REMARKS

In the Office Action of December 28, 2007, the Examiner first objected to the drawings under 37 C.F.R. 1.83(a) as not showing a particular recitation in Claim 4 directed to “a second substrate having a flat surface profile and an alignment layer formed thereon” and said “LC molecules aligning parallel to the alignment direction of said second substrate”

With respect to the 35 U.S.C. §112, first paragraph rejection of Claim 7 applicants provide a simple illustration below labeled drawing “A” detailing, for the Examiner’s edification, the origin of the 90-degree meta-stable state:

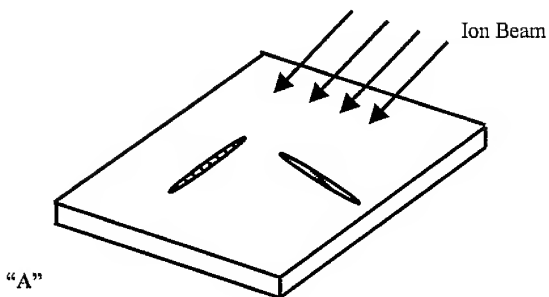
Further in the Office Action, the Examiner rejected Claims 2-11 and 18 under 35 U.S.C. §112, first paragraph, as allegedly failing to comply with the written description requirement. The Examiner particularly took issue with the last clause of Claim 4 (“aligning molecules parallel to the alignment direction of the second substrate”), and, the recitation of Claim 5 including a “second substrate aligned opposite the first substrate to include a top alignment layer having a grooved surface profile”.

This drawing particularly illustrates for the Examiner how, on a “flat” alignment layer or substrate surface with IB beam alignment, molecule 301 and 302 have same potential energy; and that, as shown in proposed new Fig. 6, the LC molecule 301 which is sitting inside the groove has a lower potential energy than molecule 302 that is sitting on the ridge of the groove. The grooved structure increase anchoring energy by reducing the potential energy of the molecules when they are situated along the groove. The recitation in rejected Claim 7 is directed to this concept of reducing the potential energy of the molecules when they are situated along the groove with full support in the specification as filed and the new proposed drawing figures illustrating the embodiment of Claim 7 having a flat surface profile for the “second” (top) substrate.

In view of the foregoing, Applicants respectfully submit that the recitations relied upon in the rejection of Claims 5 and 7, as amended, are a result of the methodology described herein and illustrated, particularly in new proposed Fig. 6 and the additional drawing "A" provided for the Examiner's edification, and additionally, when gleaned from the paragraphs ¶[0022] and ¶[0023] of the originally filed specification.
